Economic Commission for Europe**Inland Transport Committee****World Forum for Harmonization of Vehicle Regulations****182nd session**

**Proposal for the 04 series of amendments to UN Regulation
No. 94 (Frontal collision protection)****Submitted by the Working Party on Passive Safety ***

The text reproduced below was adopted by the Working Party on Passive Safety (GRSP) at its sixty-fifth session (ECE/TRANS/WP.29/GRSP/67, para. 17). It is based on ECE/TRANS/WP.29/GRSP/2020/4 as amended by Annex VI to the report. It is submitted to the World Forum for Harmonization of Vehicle Regulations (WP.29) and to the Administrative Committee (AC.1) for consideration at their November 2020 sessions.

Model B

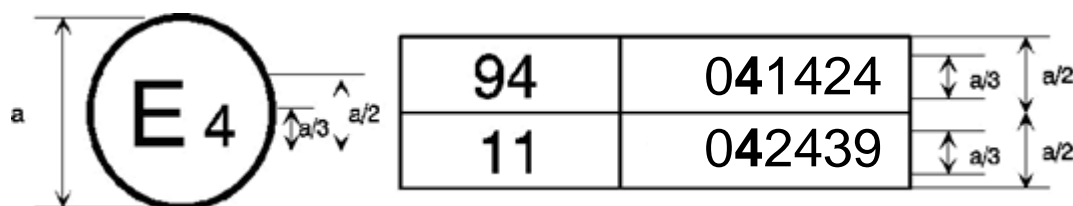
Annex 2, amend to read:

The first two digits of the approval numbers indicate that, at the dates when the respective approvals were granted, UN Regulation No. 94 incorporated the 04 series of amendments and UN Regulation No. 11 incorporated the 04 series of amendments."

Figure 3
Jointed Test Finger

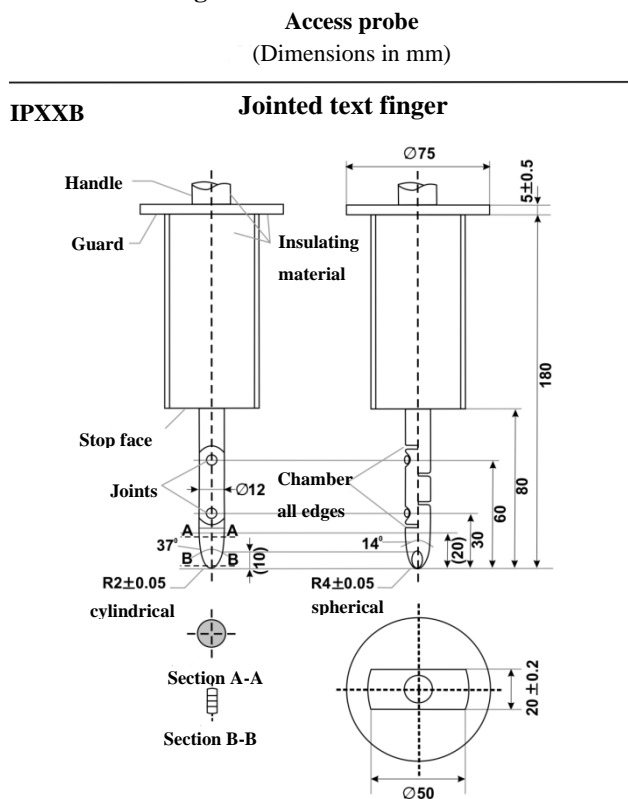
The jointed test finger described in Figure 3 shall be inserted into any gaps or openings of the physical protection with a test force of $10 \text{ N} \pm 10$ per cent for electrical safety assessment. If partial or full penetration into the physical protection by the jointed test finger occurs, the jointed test finger shall be placed in every position as specified below.

The requirements of paragraph 5.2.8.1.3. of this Regulation are met if the jointed test finger described in Figure 3, is unable to contact high voltage live parts.

Figure 4

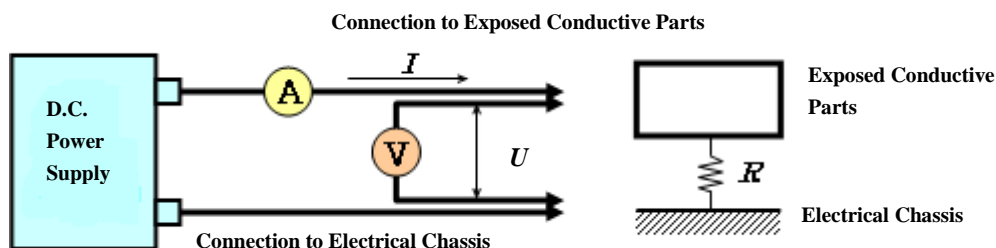
- #### 4.1. Test method for measuring electric resistance:

Example of the test method using DC power supply, voltmeter and ammeter is shown below.

Figure 5

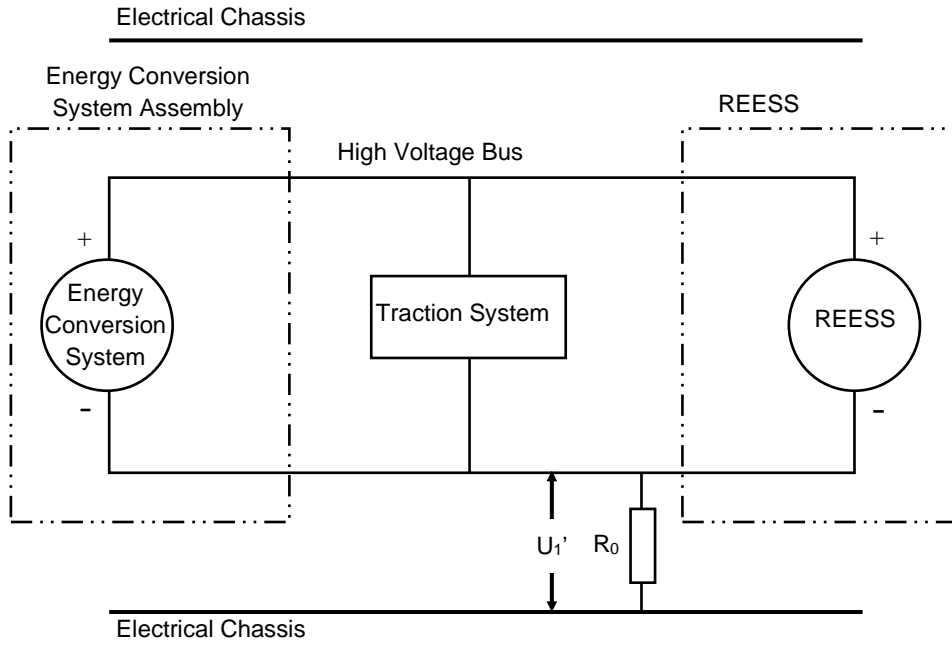
If U_1 is greater than or equal to U_2 , a standard known resistance (R_o) is inserted between the negative side of the high voltage bus and the electrical chassis. With R_o installed, the voltage (U_1') between the negative side of the high voltage bus and the electrical chassis is measured (see Figure 5).

$$R_i = R_o * U_b * (1/U_1' - 1/U_1)$$

Figure 6
Measurement of U_2'

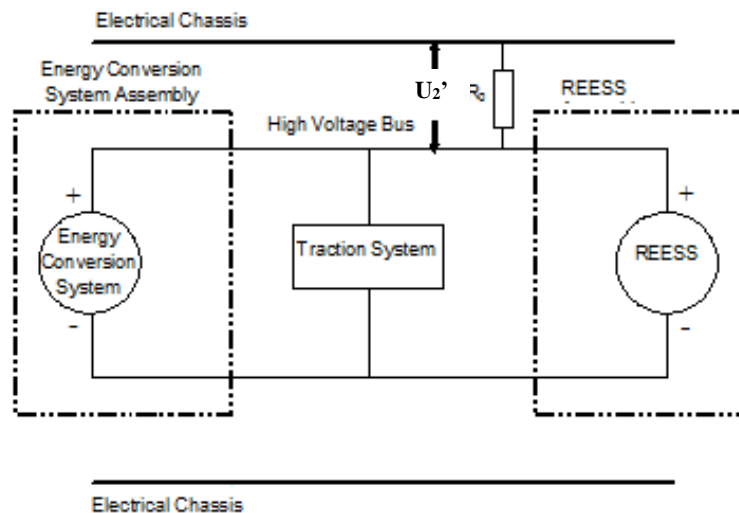
If U_2 is greater than U_1 , insert a standard known resistance (R_o) between the positive side of the high voltage bus and the electrical chassis. With R_o installed, measure the voltage (U_2') between the positive side of the high voltage bus and the electrical chassis (see Figure 6 below). The electrical isolation (R_i) is calculated according to the following formula:

$$R_i = R_o * U_b * (1/U_2' - 1/U_2)$$
